STAFF CORRECTIONS TO ATTACHMENT B

Downtown Livability Height and Form Recommendations

Attachment B

Downtown Mixed-Use (DT-MU), Residential

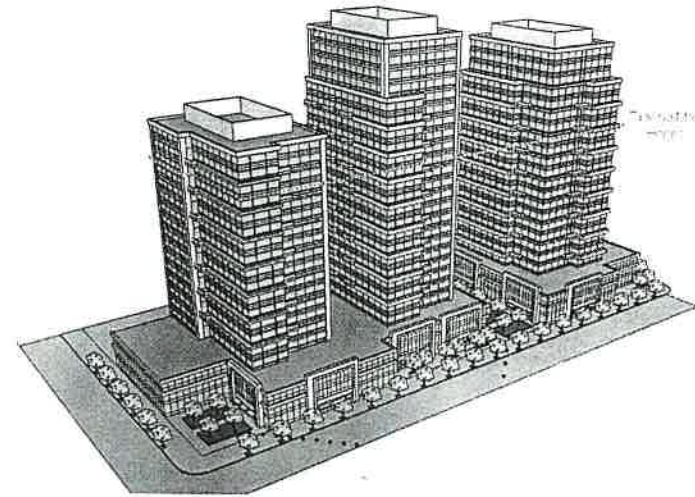
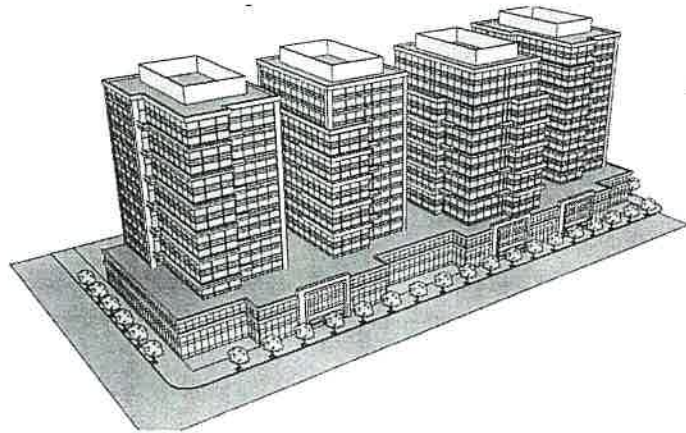
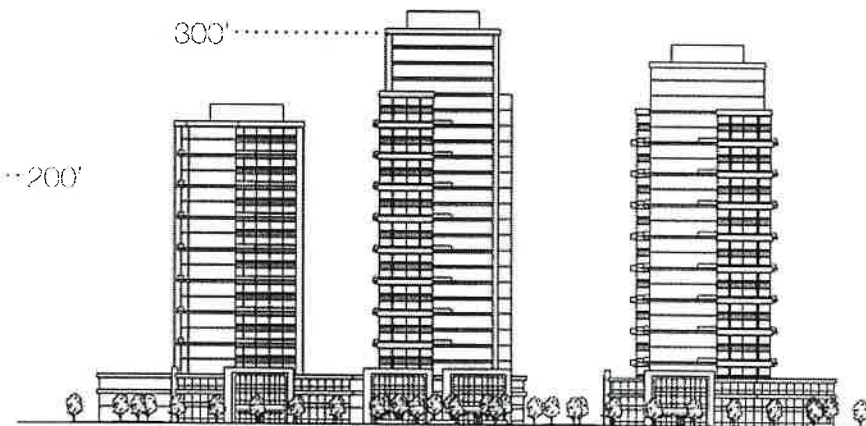
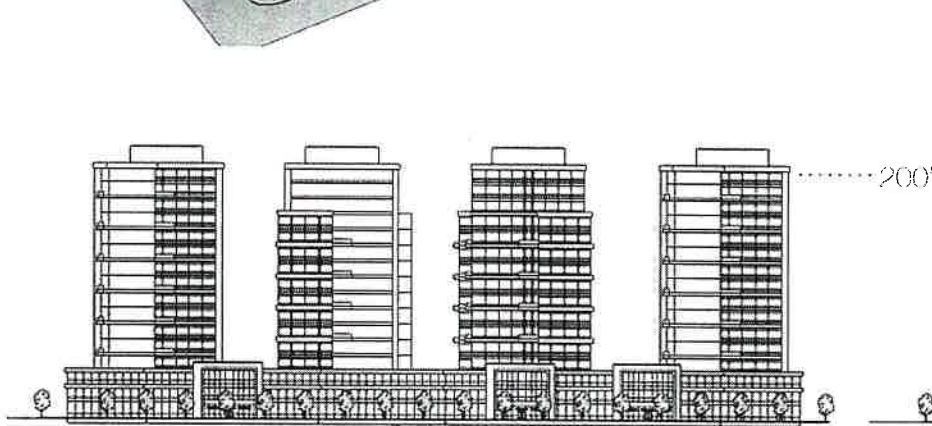
- 5.0 FAR (no change)
- 300 ft height limit*

Downtown – Deep “B”, Residential

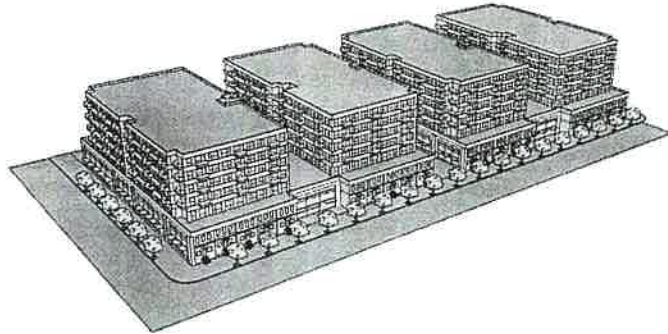
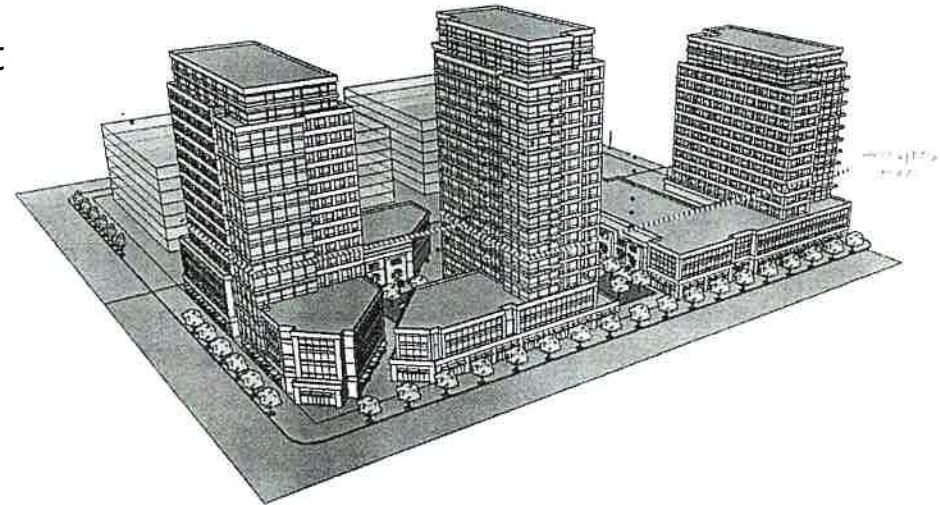
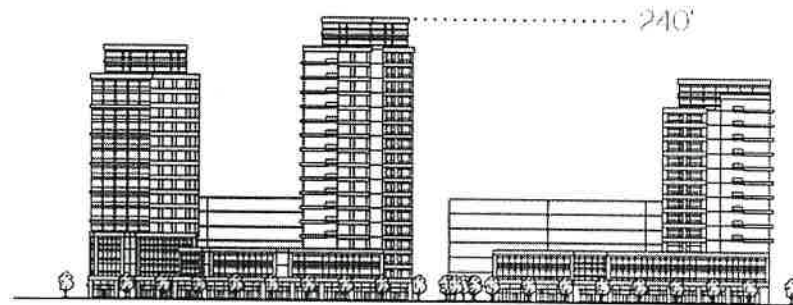
5.0 FAR (no change)

160-240 ft w/ 200 ft average height limit

160 ft for single building project*

Downtown-01, Residential

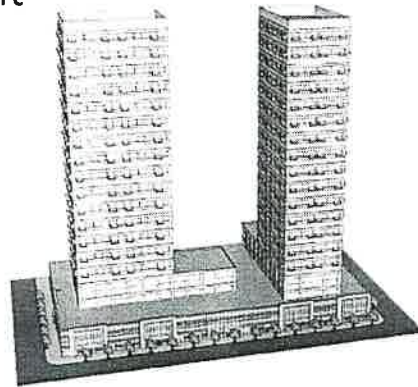
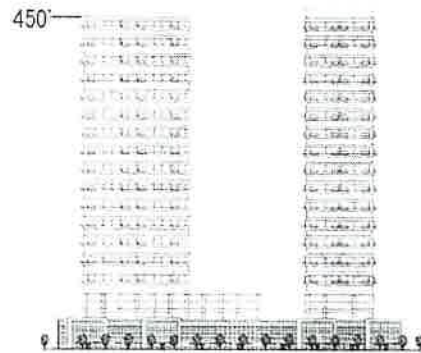
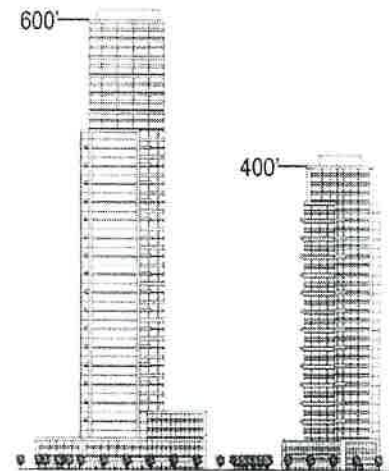
- 10.0 FAR
- 600 ft height limit

Downtown-O2 North of NE 8th Street, Residential

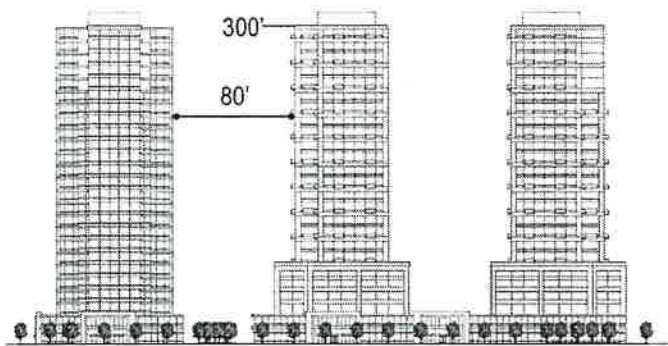
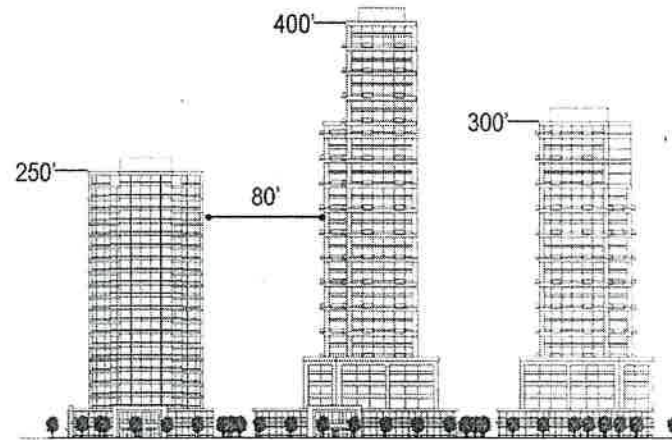
- ~~7.0 FAR~~ 6.0 FAR (no change)
- 400 ft height limit*

Downton-O2 South of NE 4th Street, Residential

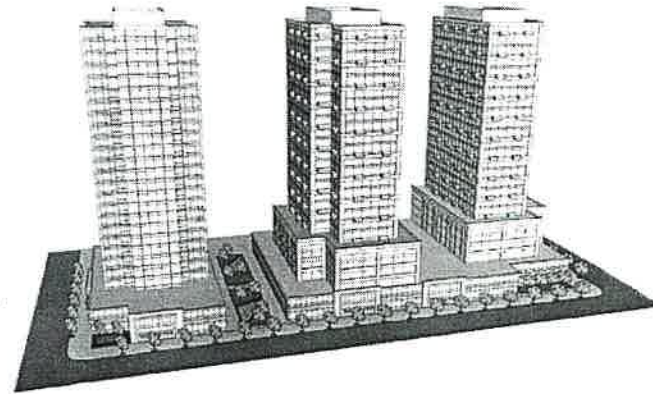
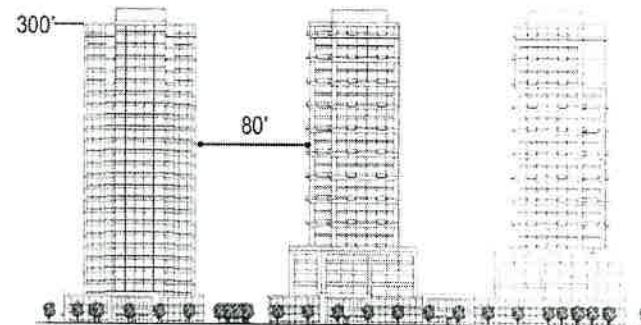
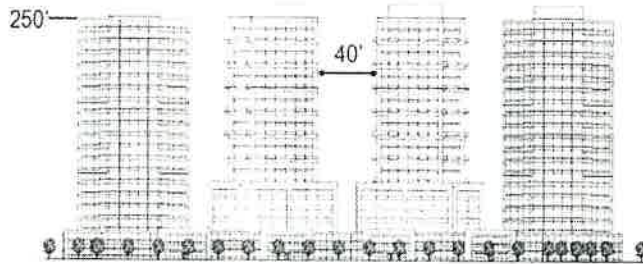
- 6.0 FAR (no change)
- 300 ft height limit*
